**RE: 142 40<sup>th</sup> Street SW**  
**Revised Grading & Drainage Plan**  
**Engineer's Stamp Date: 04/06/20**  
**Hydrology File: K12D037**

RE: 142 40<sup>th</sup> Street, SW Apart. Building Grading Plan, Hydrology File# K12D037

**142 40TH STREET, SW  
GRADING AND DRAINAGE PLAN**

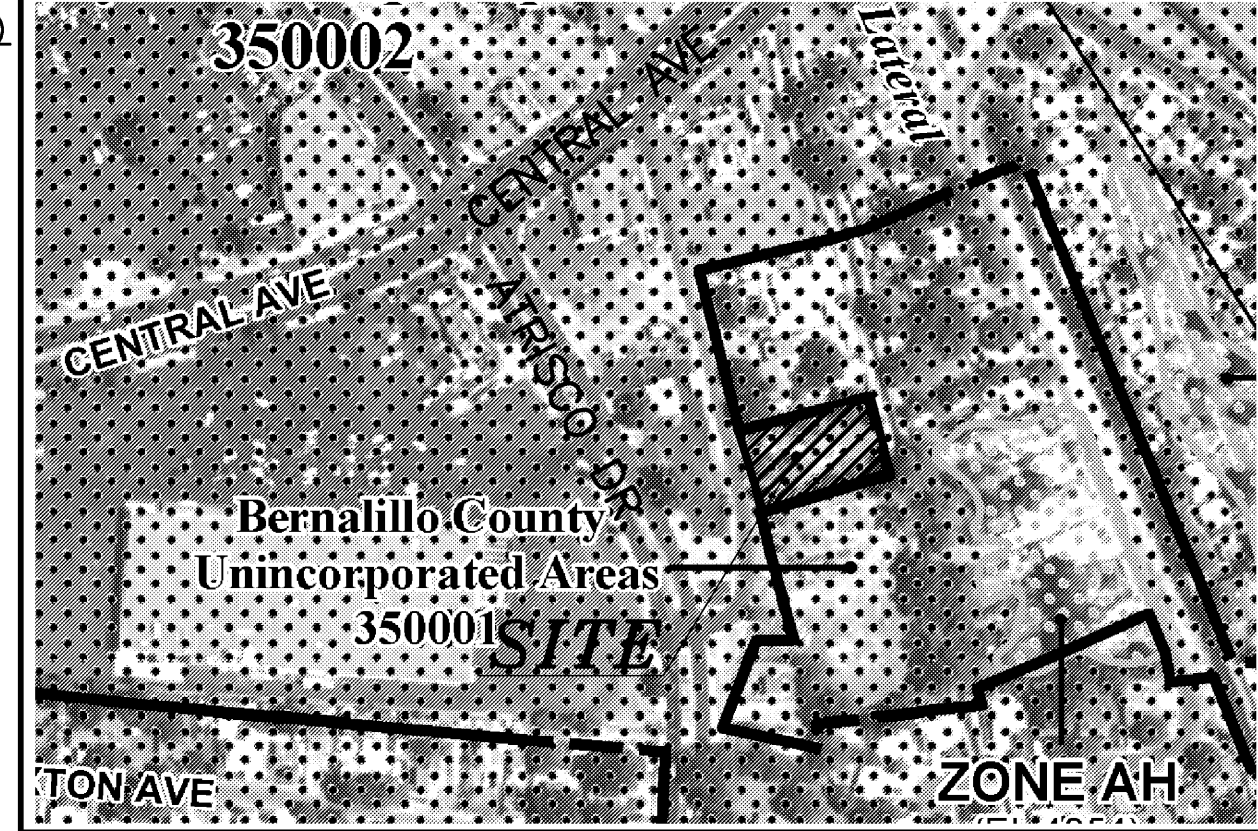
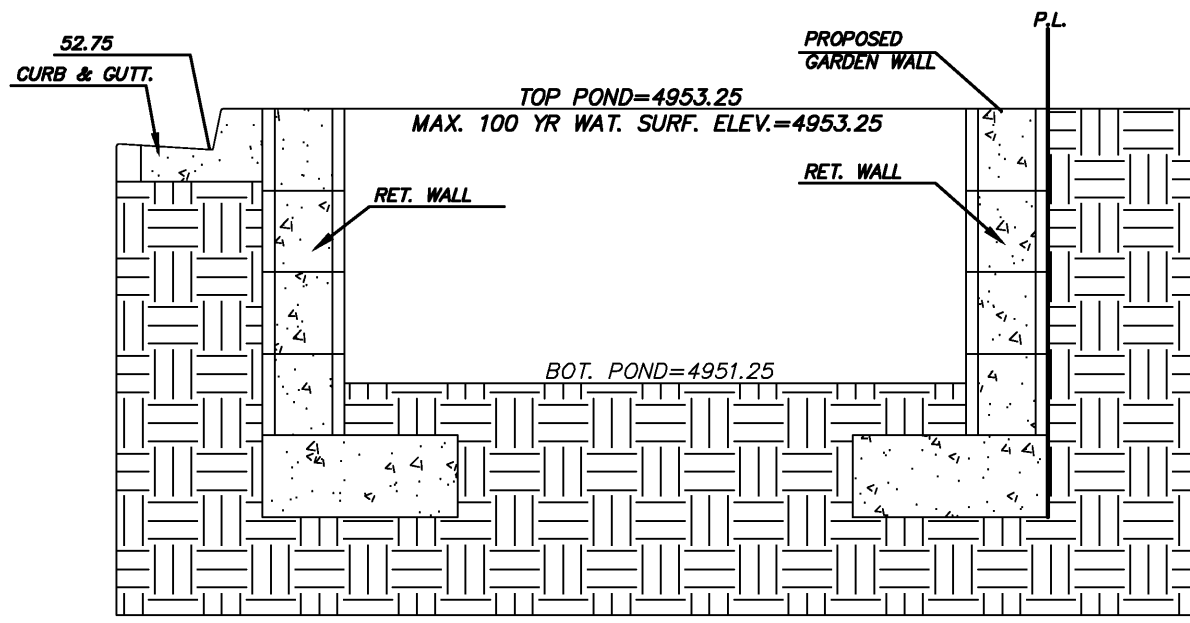
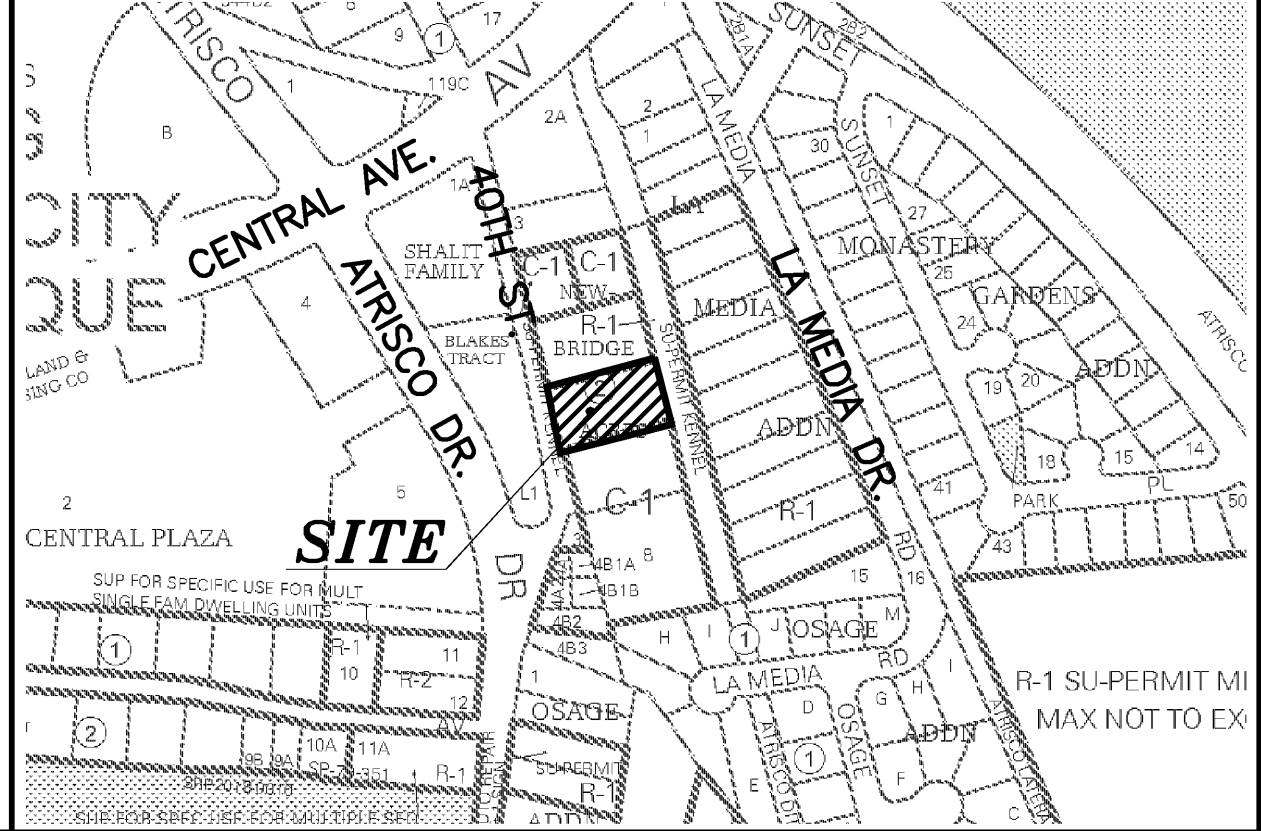
- 5) The calculation has been revised and the entire volume would be kept onsite. The volume in addition to 45% have provided in ponding.  
The 100 year-10 day stormwater surface elevation is 4953.25 and the finished floor elevation is 4956.00 (pad elevation =4955.66).  
The flow between front and backyard will not be obstructed. The ponds are both same elevation and connected with 2-4" pipe to be equal in level of water. The pond along back of the building is removed as well.  
The flow line elevation at street are 4953.54 and 4953.56. This is based on the existing road elevations. We really cannot change the grade on the existing road, however, the 100 year-10 day water surface elevation is 5953.25 which is very close to requested 4" (.33'). There is only 0.02' to .04' difference.

7) No water will be discharged into 40<sup>th</sup> Street and the sidewalk culvert and SO-19 was removed.

8) The section for the ponds with water surface elevation is provided. The retaining walls will be L footing to not encroach in any adjacent properties.
